From: Blair, Ruth [mailto:Ruth.Blair@balfourbeatty.com]
Sent: 25 June 2018 16:11
To: Webster, Gemma (Senior Planning Officer) <Gemma.Webster2@herefordshire.gov.uk>
Cc: Hockenhull, Joel <Joel.Hockenhull@balfourbeatty.com>
Subject: 181978 - Land At Stone Farm, Felton, HR1 3PW comments

SITE: Land At Stone Farm, Felton, Herefordshire, HR1 3PW
TYPE: Planning Permission
DESCRIPTION: Proposed residential development comprising 3 no. self-build dwellings and associated works
APPLICATION NO: 181975
GRID REFERENCE: OS 357438, 248723
APPLICANT: Mr David Abell
AGENT: Mr Matt Tompkins

Figure 1: Environment Agency Flood Map for Planning (Rivers and Sea), June 2018

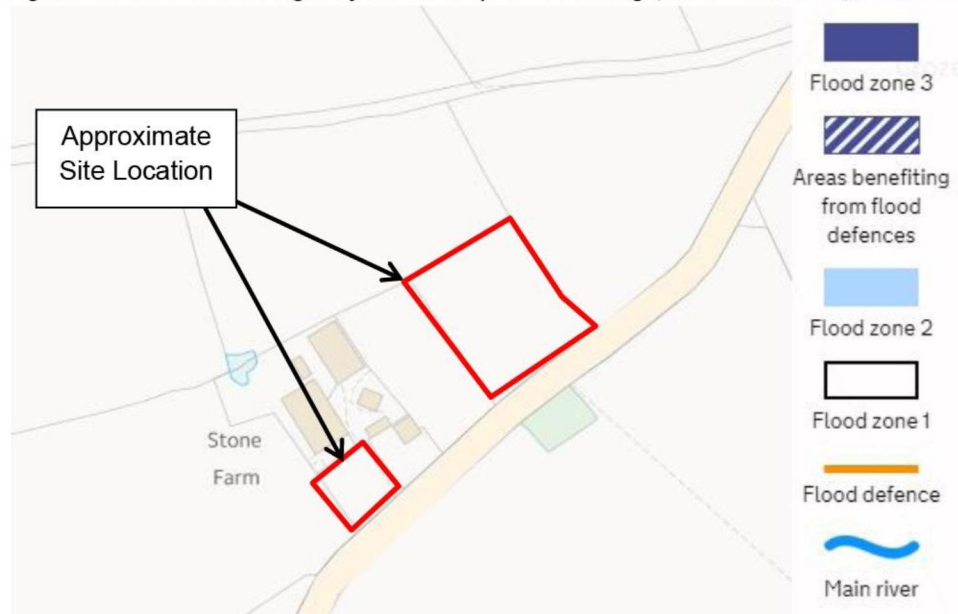
Review of the Environment Agency's Flood Map for Planning (Figure 1) indicates that the site is located within the low risk Flood Zone 1.
